REPORT

SOIL CONDITIONS AND FOUNDATIONS

PROPOSED BUTTERMILK FALLS CROSSING

HIGHWAY NO. 35 - LINE G

PRELIMINARY PLAN

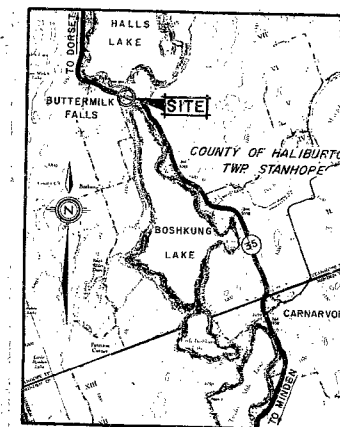
The foundation investigation report for this structure, prepared by H. Q. Golder & Associates Ltd., recommends placing rock fill at the base of the east bank to form a stable slope to the underside of the footing level.

Because of the proximity of the Department of Transport's downstream dam to the proposed structure; the substantial constriction on the waterway by any fill placed against the east bank; and the particularly aesthetic appearance of the existing rock face; we would suggest that the east abutment be located at a minimum offset of 5 feet from the rock face as an alternate to placing the rock fill against the east bank. This bank could be observed as time goes on and if it showed signs of further deterioration, measures could be taken to ensure its stability at that time.

A copy of the preliminary bridge plan is enclosed for your information. This plan shows the limits of the rock fill if it were placed against the east bank.

Your proposal to place the east abutment footing a minimum of 5 ft. back from the rock face as an alternative to placing rock fill in front of the rock face, seems reasonable and we would agree with it. However, we would strongly recommend that a thorough and careful inspection of the rock face and the rock, in general, be undertaken once the excavation for the abutment is completed and before the superstructure is built. Should any faults or other signs of rock instability be found, remedial measures such as prestressed rock anchors, should be resorted to. We believe that such measures will not be necessary, but we would like to make sure that this belief is verified during construction, and that all is done to make sure that the foundation is safe.
